Kite Split replacement to new version**DESCRIPTION:**

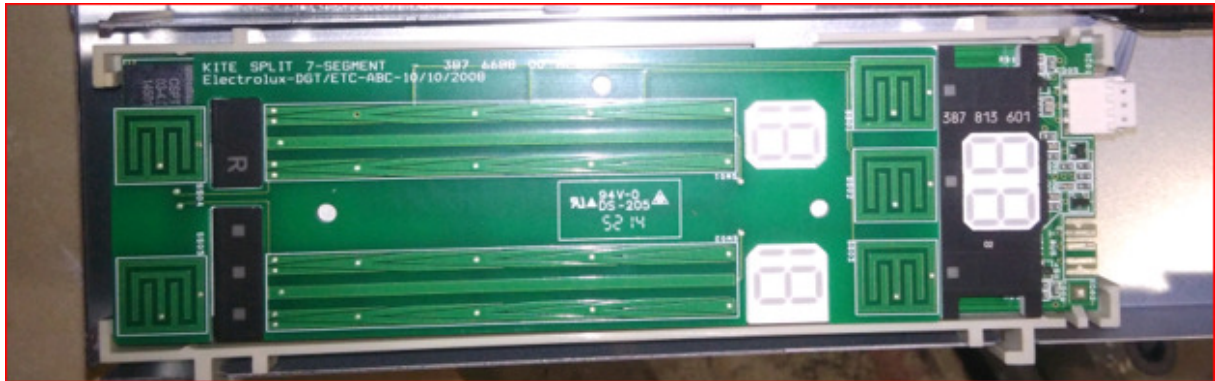
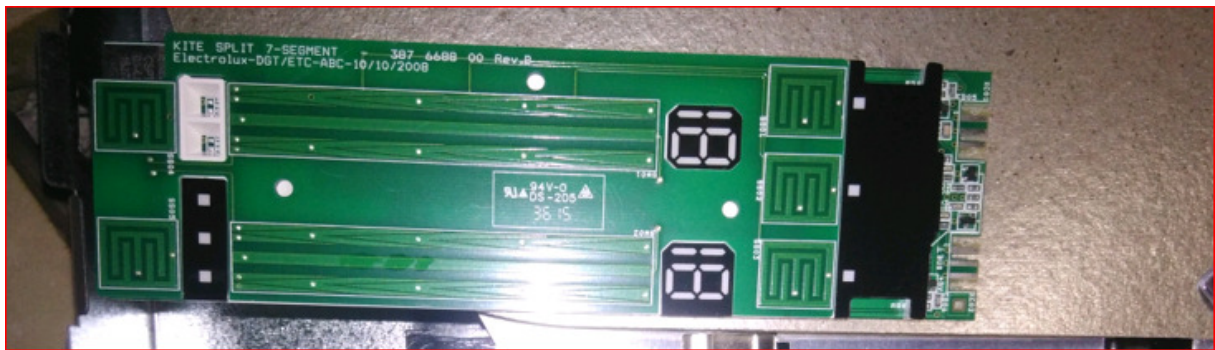
User interface Kite Split has been replaced in production with a new version. Electronics are not compatible and cannot be mixed within one appliance.

1. OLD USER INTERFACE - Kite Split
White 7-segment displays, laser engraved markings.

2. NEW USER INTERFACE - Kite Split with foil
Black 7-segment displays, markings on additional foil.

For appliances produced before serial number 601xxxxx it is necessary to replace both boards - left and right.
